P 526171

ON-SITE SEWAGE DISPOSAL SYSTEM HOWARD COUNTY HEALTH DEPARTMENT BUREAU OF ENVIRONMENTAL HEALTH

ADDRESS: 1264 Cornelius Court PROPERTY OWNER: Linda Brown

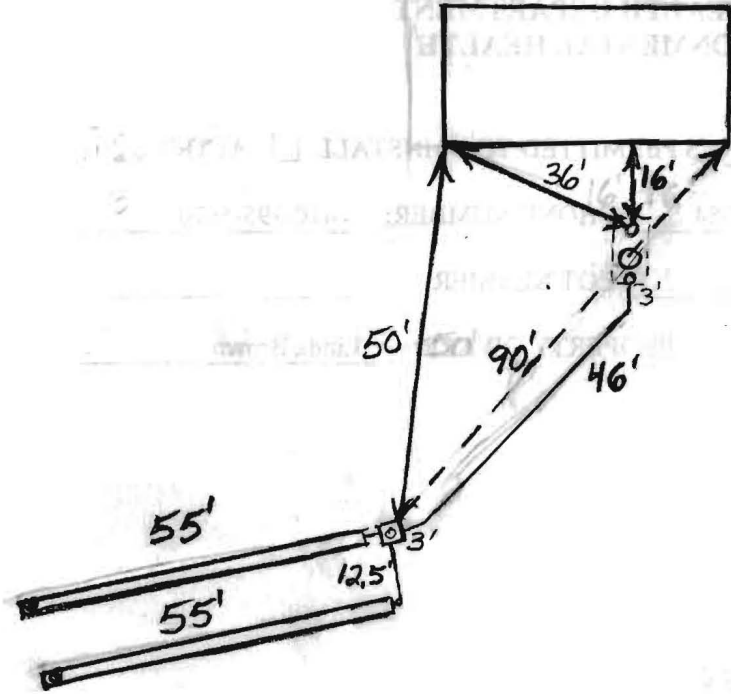
INSTALLATION 2/20/07 Trenches were installed somewhat off contour but trench bottoms are level. Trenches are ~ 1 foot deeper near distribution box. O.K. to backfill.
